Access Compliance Report

Public Rights-of-Way

(Curb Ramps)

Intersection ID: 10038802	Main Street: STEELE_CREEK_RD	Cross Street: N/A	Location: NE
ADA ID: E45EEF0BB794	Ramp Type: BlendTrans1	Initial Pass/Fail: Fail	Overall Compliance: No
Severity Score: 10			
Codes/Mitigation Info/Possible Solution		Field Measurements/Component Compliance

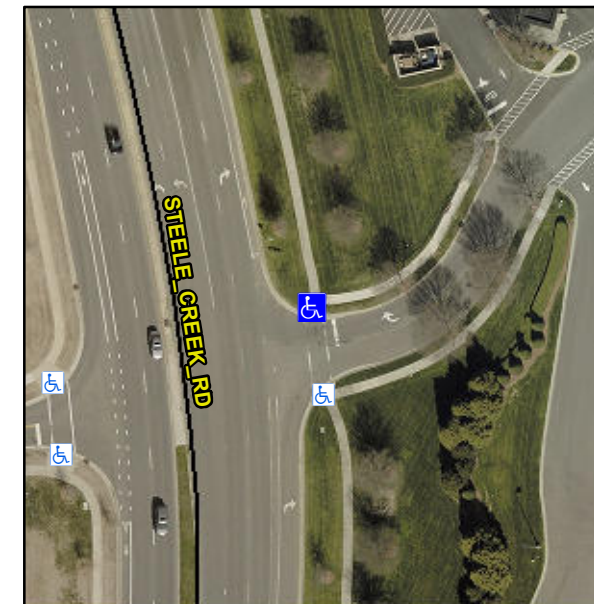
Not Found, R304.5.1, R304.5.3

Compliance	Description	Data	Compliance	Description	Data
N/A	Ramp Length (in)	56.0	Yes	BlendTrans Slope (%)	1.0
No	Ramp Width (in)	47.0	No	BlendTrans XSlope (%)	2.8
N/A	Flare Type LT	N/A	N/A	Flare Type RT	N/A
N/A	Flare Slope LT (%)	N/A	N/A	Flare Slope RT (%)	N/A
N/A	Flare Traversable LT?	N/A	N/A	Flare Traversable RT?	N/A
N/A	Landing Length (in)	N/A	N/A	DWS Provided?	N/A
N/A	Landing Width (in)	N/A	N/A	DWS Contrast?	N/A
N/A	Landing Slope (%)	N/A	N/A	DWS Length (in)	N/A
N/A	Landing X Slope (%)	N/A	N/A	DWS Full Width?	N/A
N/A	Landing Curb? (Y/N)	N/A	N/A	DWS Offset (in)	N/A
N/A	Shared Landing?	N/A			
N/A	Gutter Ponding?	N/A	N/A	Gutter Slope (%)	N/A
N/A	Gutter Lip Ht (in)	N/A	N/A	Gutter X Slope (%)	N/A
N/A	Painted X Walk1?	No	N/A	Painted X Walk2?	Yes
	X Walk 1 Direction	To W		X Walk 2 Direction	To S
	X Walk 1 Width (in)	N/A		X Walk 2 Width (in)	113.0
	X Walk 1 Slope (%)	0.1		X Walk 2 Slope (%)	1.5
	X Walk 1 X Slope (%)	0.4		X Walk 2 X Slope (%)	0.2

N/A	Ramp inside XWalk1?	N/A	N/A	Ramp inside XWalk2?	Yes
	Road Slope (%)	0.6		Clear Space?	N/A
	Road X Slope (%)	0.0	N/A	Clear Space to XWalk (in)	N/A
N/A	Any Obstructions?	N/A	N/A	Storm Grate/Utility Hazard?	N/A
	Obstruction Type			Storm Grate/Utility Type	
		N/A			N/A
			Yes	Surface Condition? (G/P)	Good
			No	Curb Slope (%)	18.7

Remove & Replace Curb Ramp With Two New Directional Ramps or Equivalent.
